# Access Compliance Report

## Public Rights-of-Way

### (Pedestrian Signals)

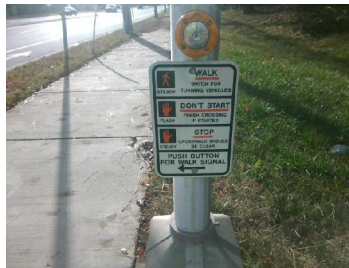
Possible Solutions: Replace Signal Push Button With APS Button on New Post. Remove & Relocate Sign.

PROW/ADA: TMUTCD 4e.08
